# Feasibility Study for Castle Peak Road Improvements

between Ka Loon Tsuen and Yau Kom Tau

**ENVIRONMENTAL IMPACT ASSESSMENT**

Report No. 97294/R38

Figure 2.8 Sensitive Receivers: Ting Kau

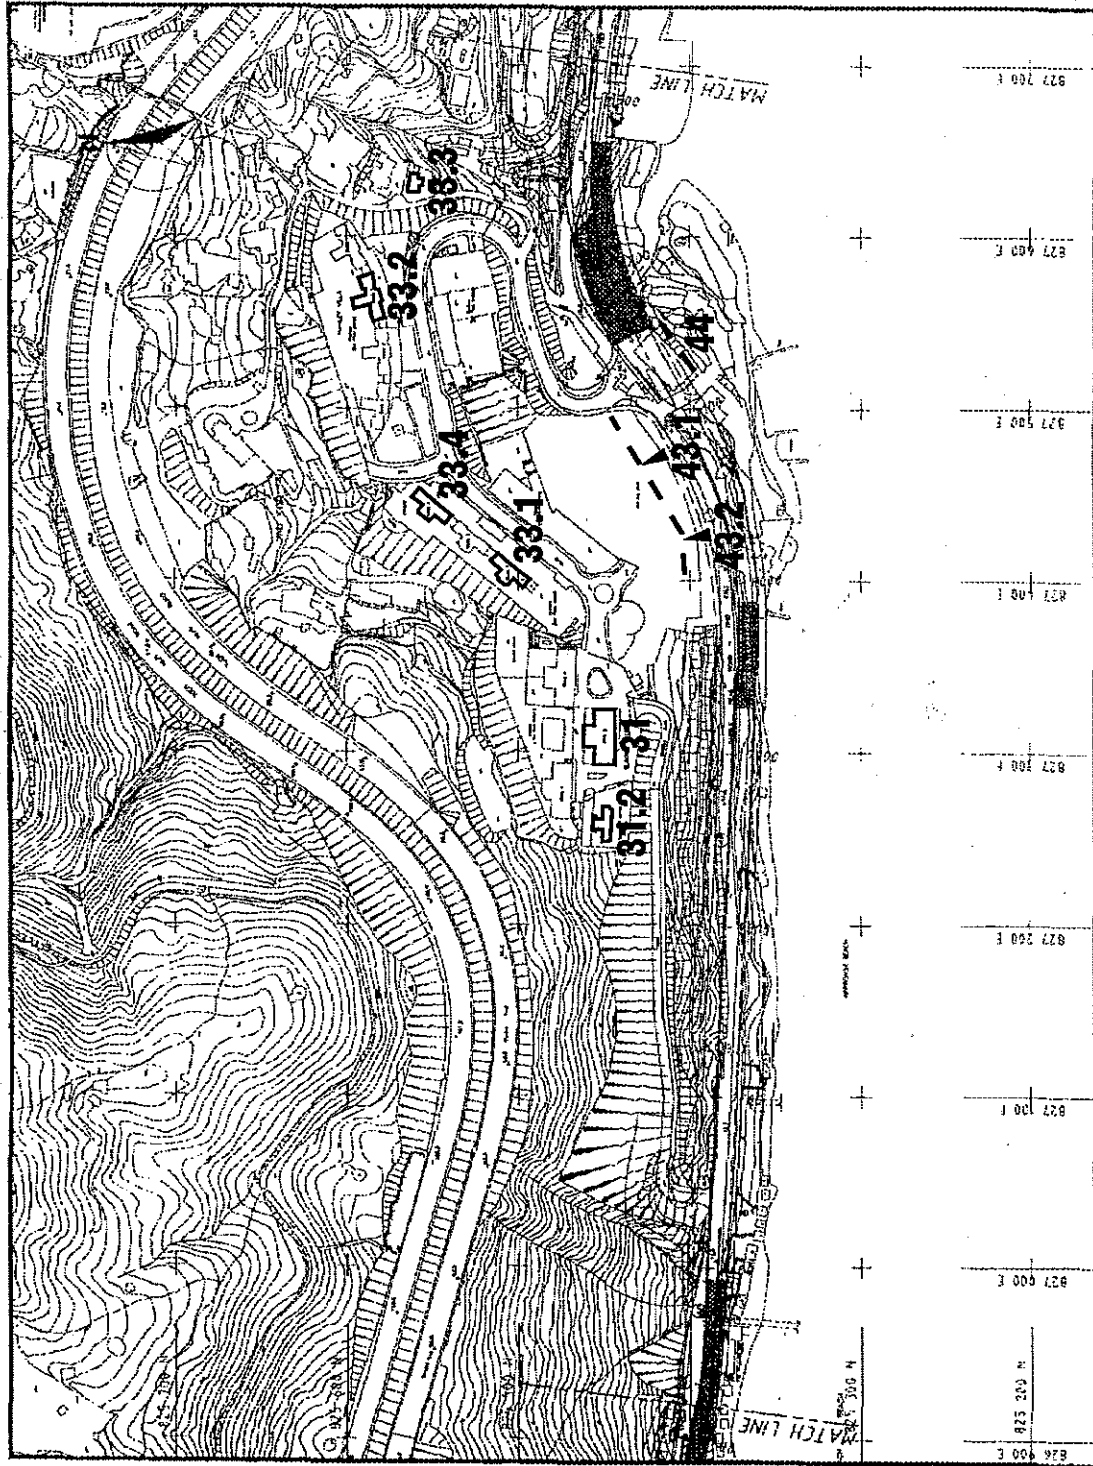
| (ii)   | Fig 2.1 to Fig 2.10, titles of these drawings do not correspond to the intended uses. Two sets of numbers, 97294 and Fig 2.1 (sketch) are presented and are confusing. Would you please revise the title and drawing number of this set of drawings.   | Rough sketches of Figures 2.1 to 2.10 were provided in the Preliminary Draft EIA as the final versions of these Figures were not yet available. Final versions of these Figures are now complete and will be presented in the Draft EIA. |

FIGURE 8.1

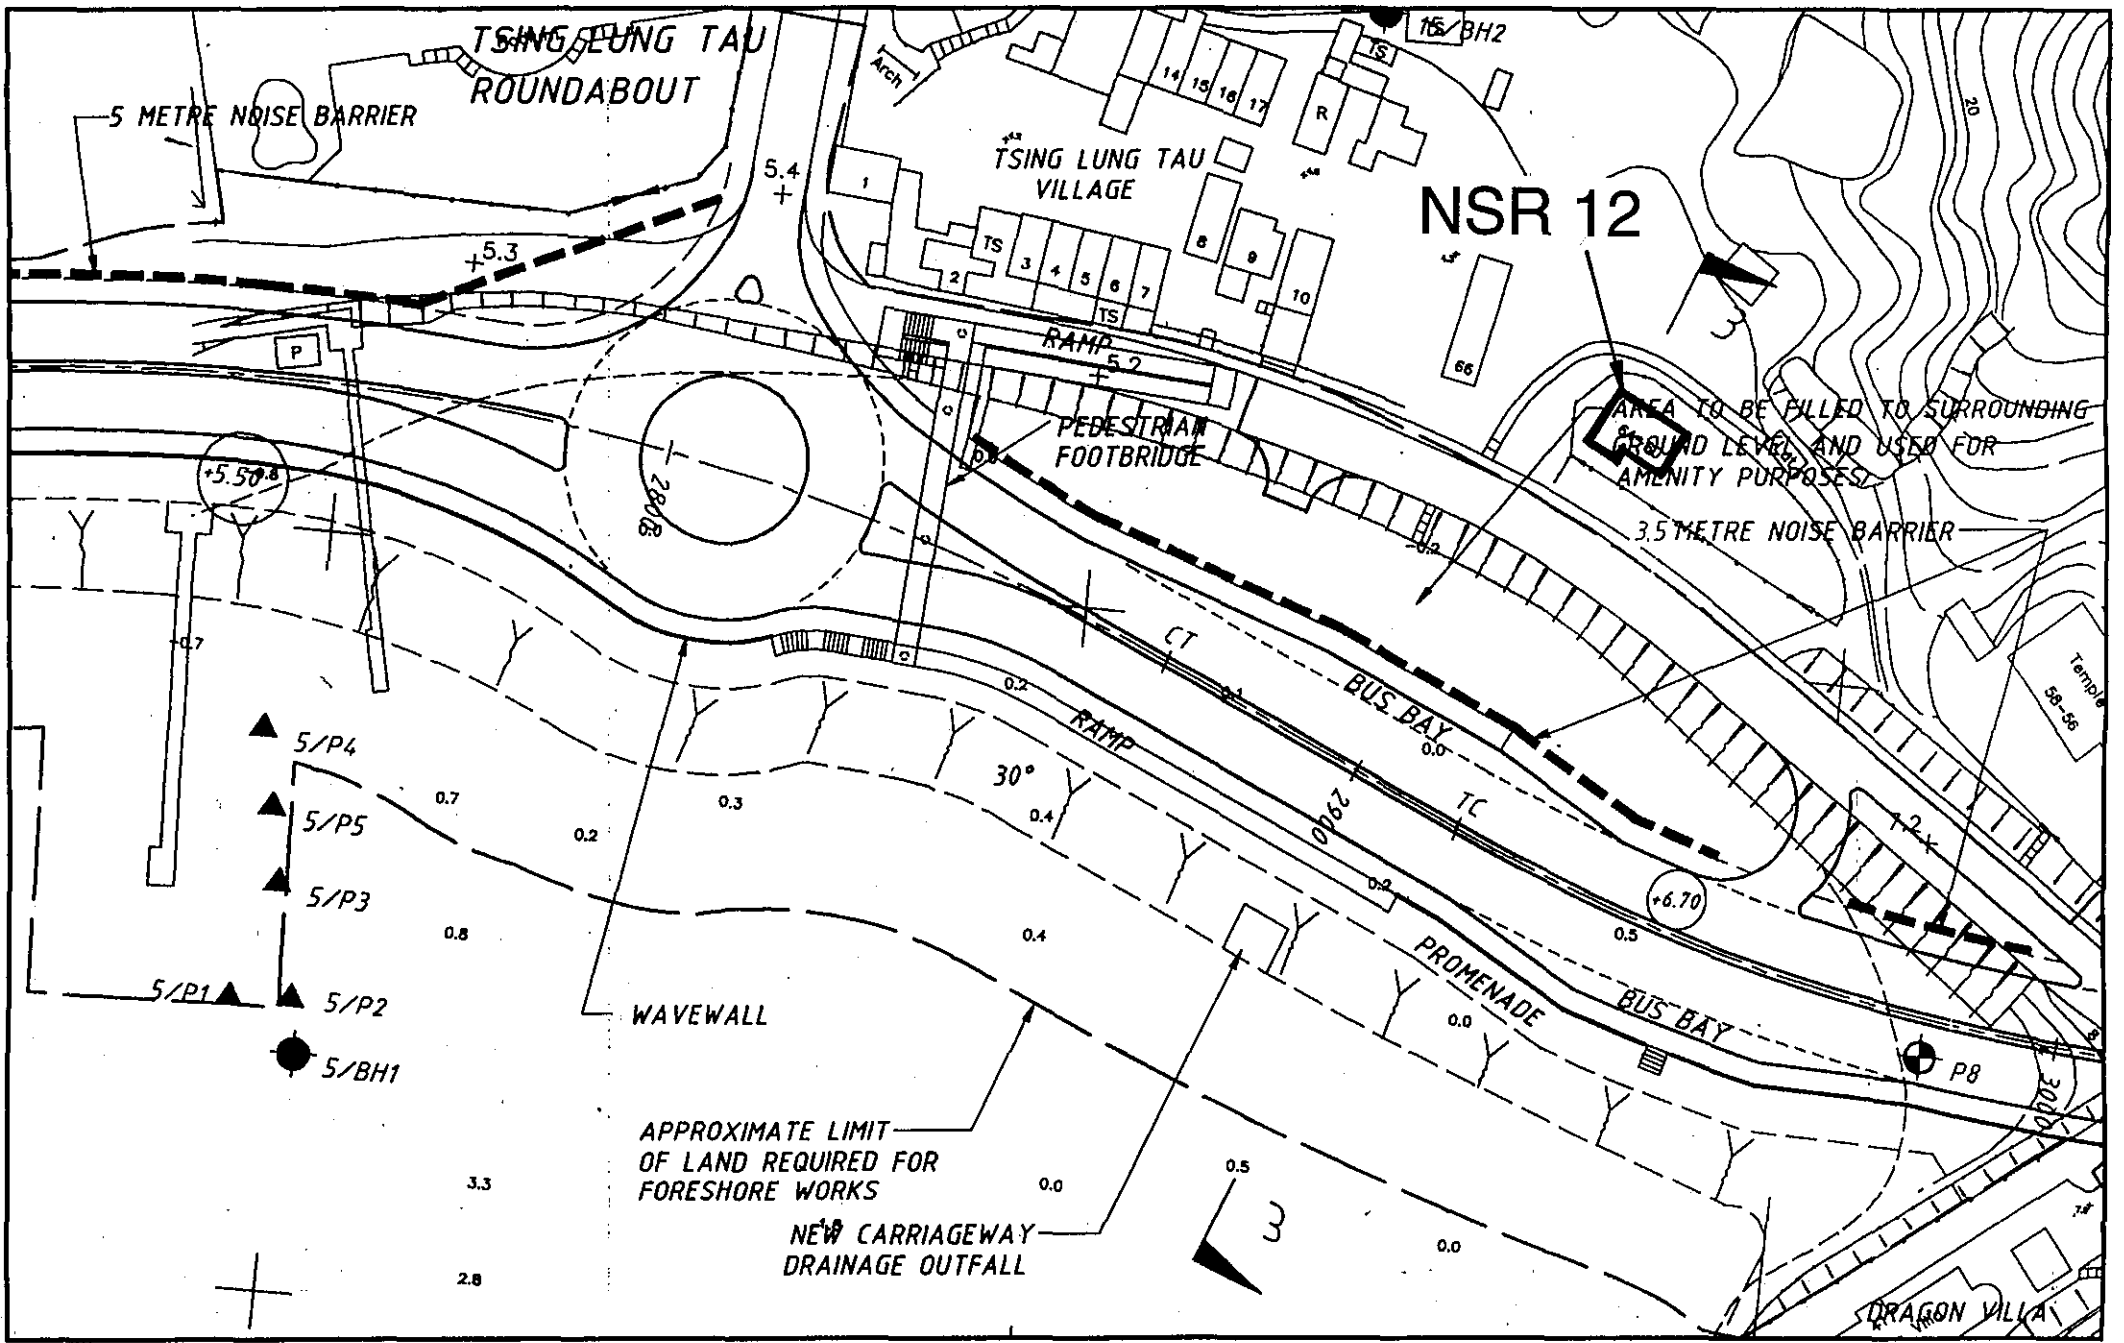
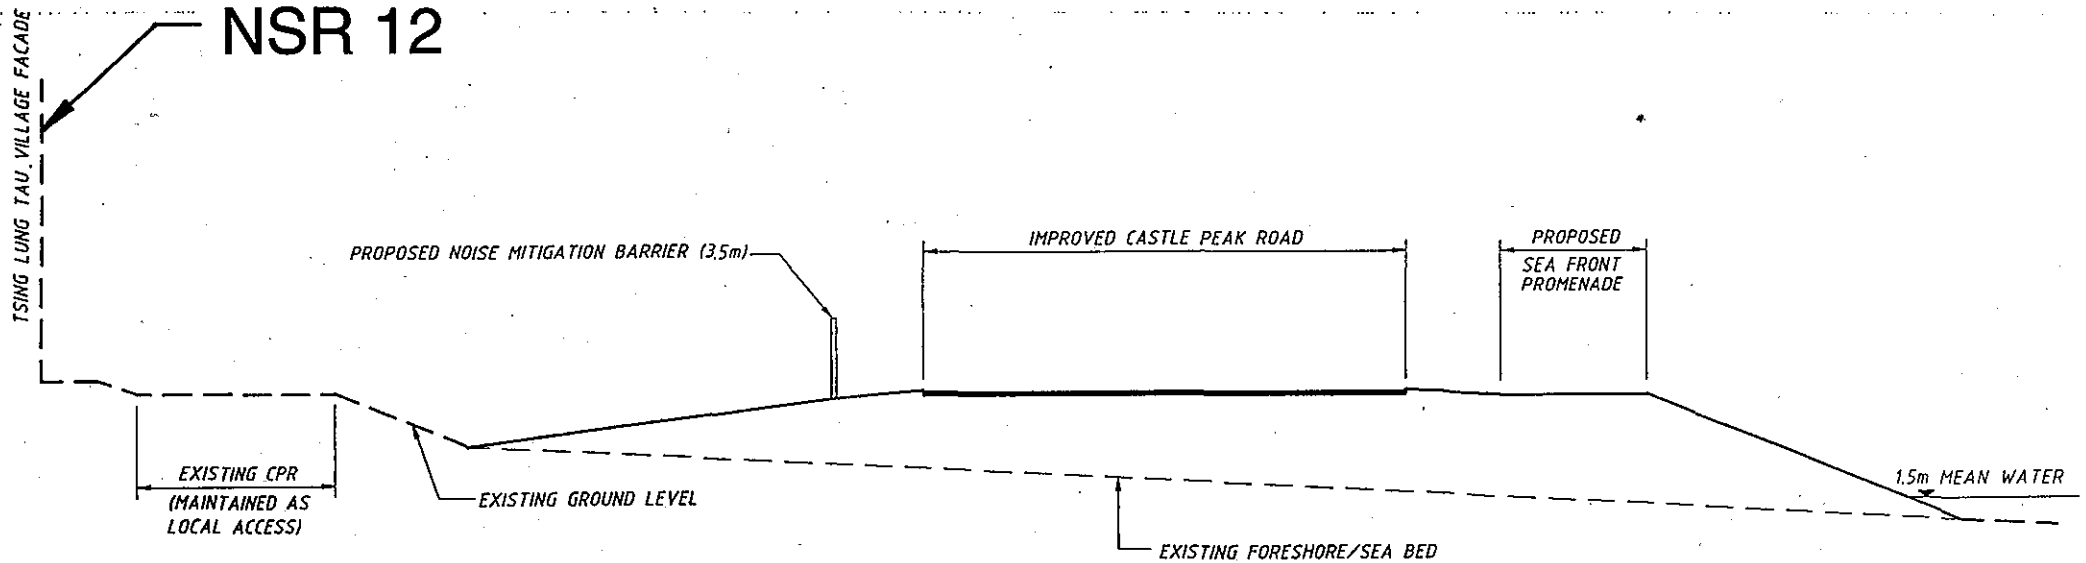
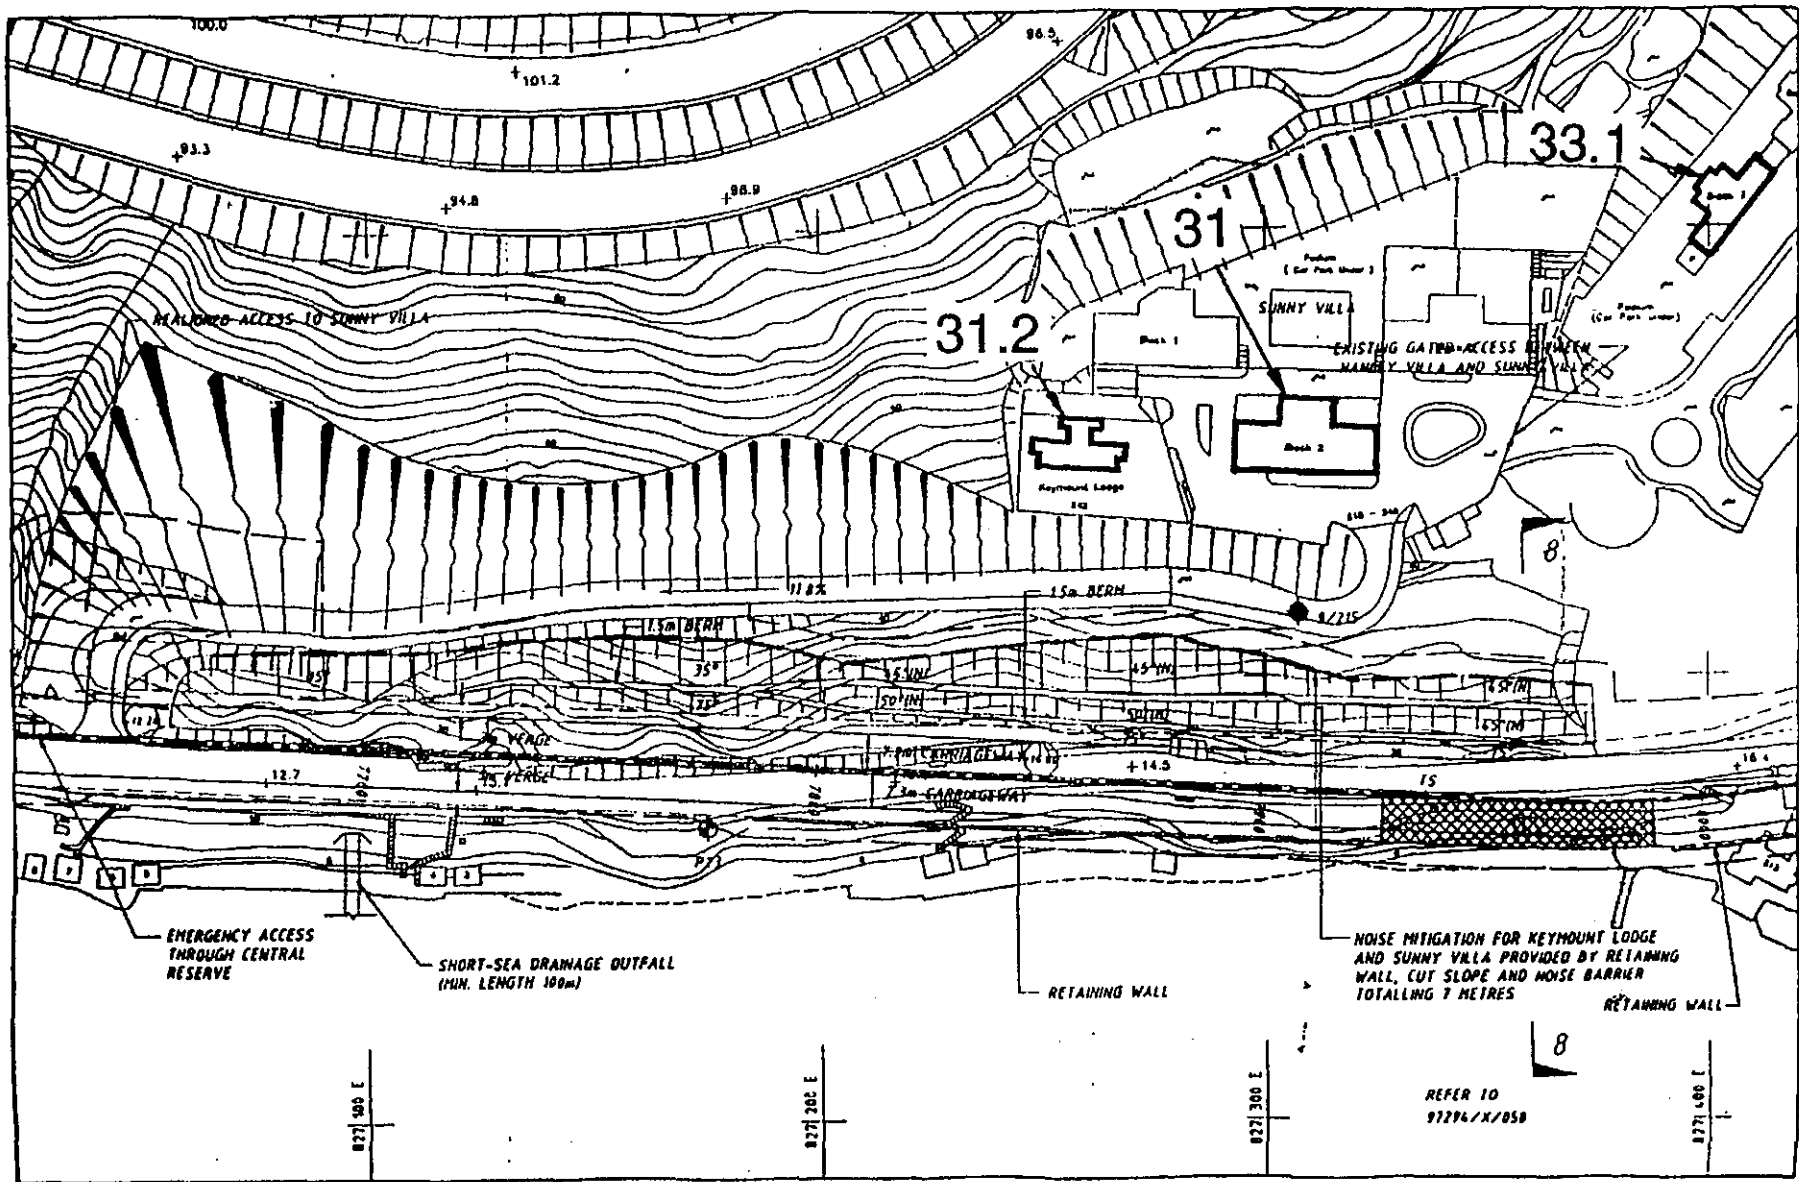
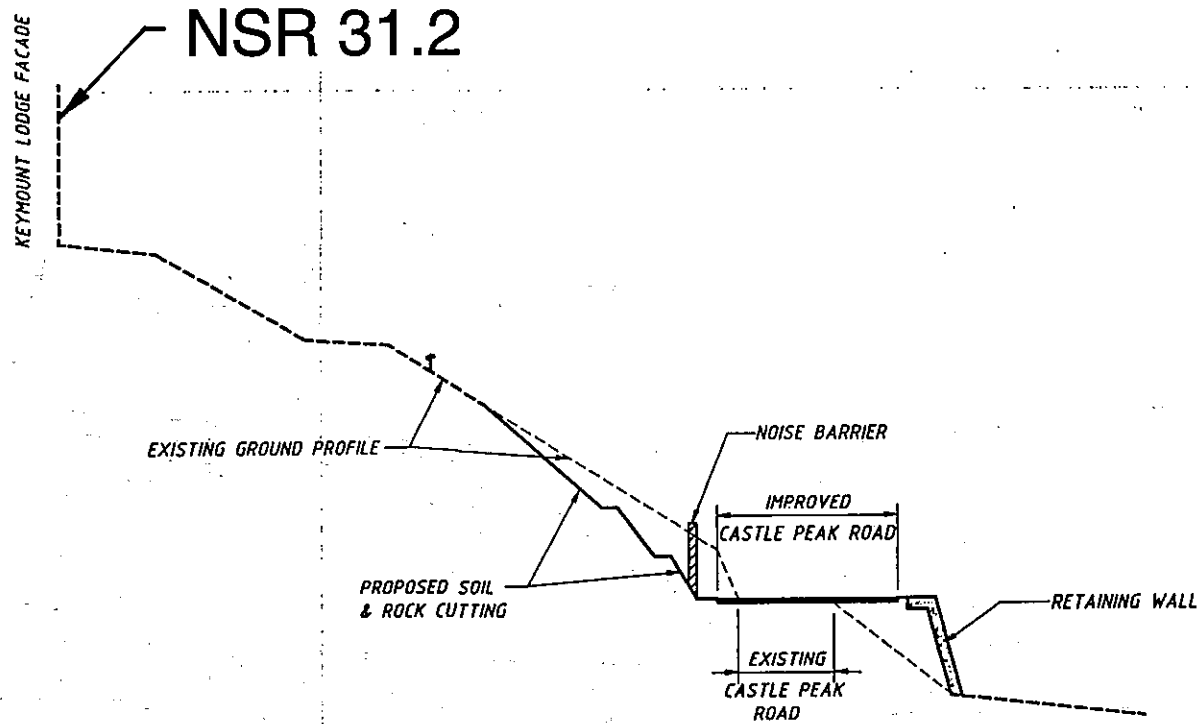
Figs 8.1 to 8.8 8. Our previous comment on 12 June 1996, item 2.13, is still outstanding.

This comment requests that locations of NSRs should be marked in Figures 8.1 to 8.8 for easy reference. Figures are being amended.
